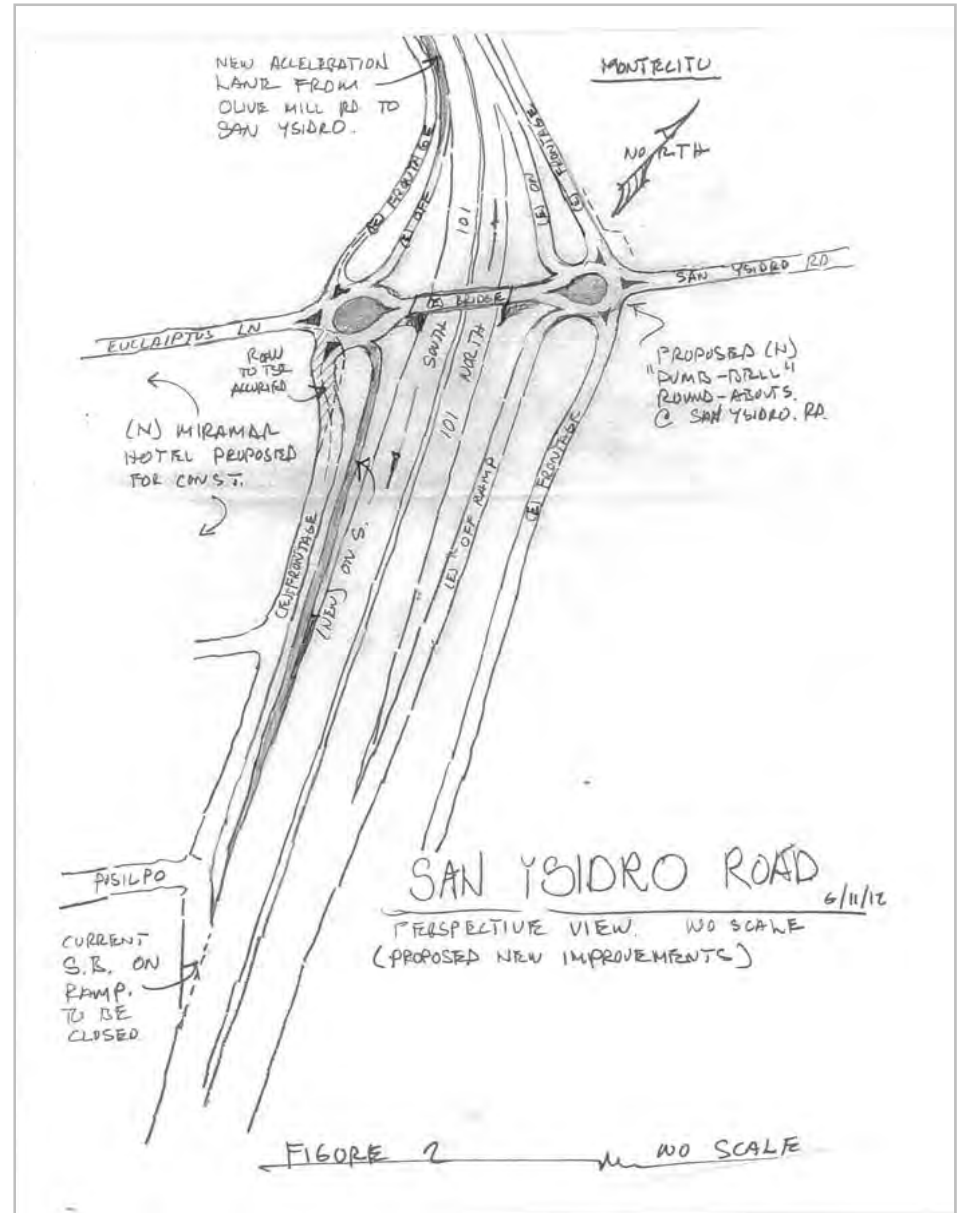
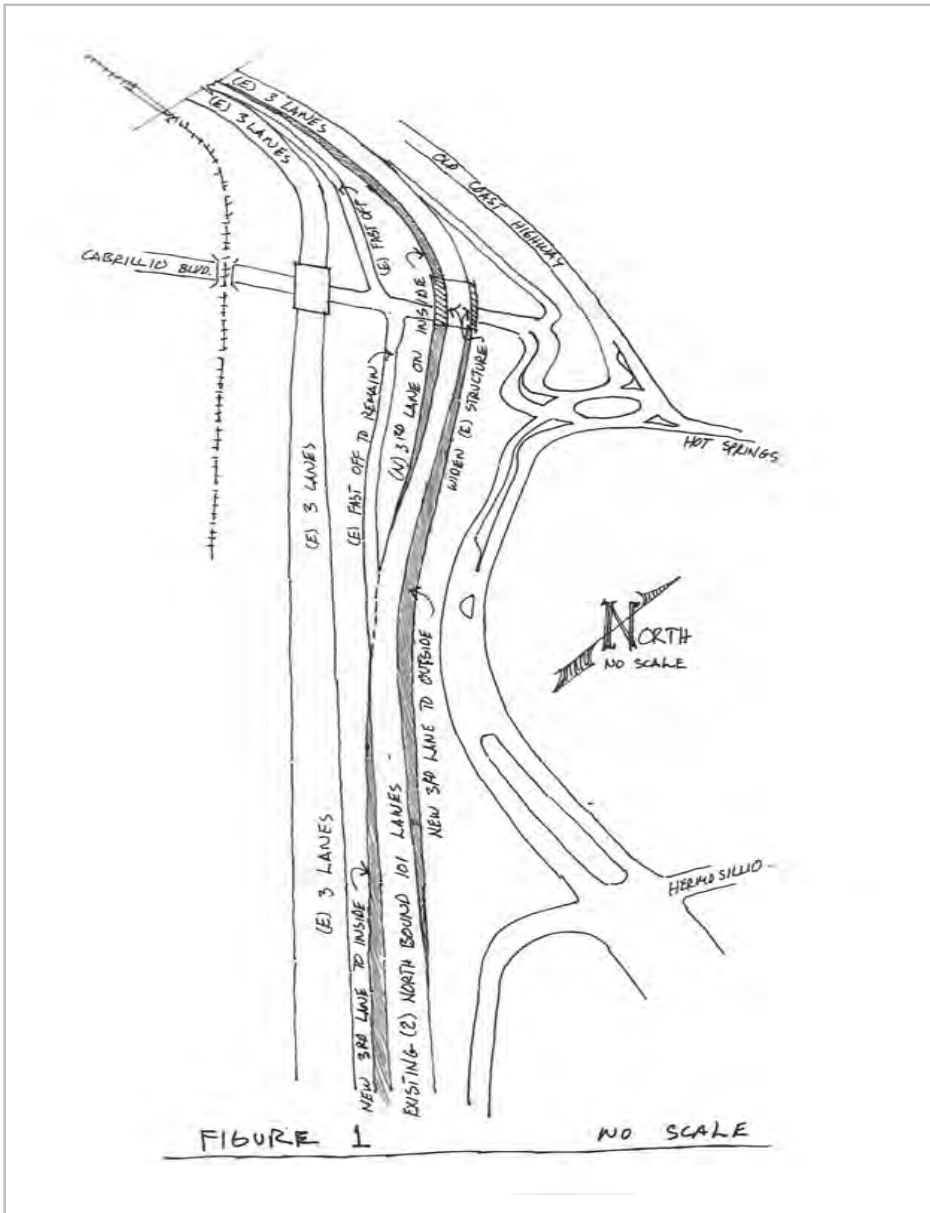
I respectfully suggest a follow-up EIR / report or study should address the above referenced issues and include simpler solutions for the Hot Springs / Cabrillo and Sheffield intersections even if they do not meet all of Caltrans Design criteria. As a suggestion I have included sketches of simpler solutions / alternates for study of these critical community intersections

Please see figures one and two attached.

The Cabrillo Boulevard/Hot Springs Road Interchange proposal submitted with your comment letter is the same as the previously evaluated project identified as Concept A. This concept was evaluated and rejected by the Project Development Team due to the need for retaining the left-side ramps that were deemed geometrically infeasible due to inadequate stopping sight distance.
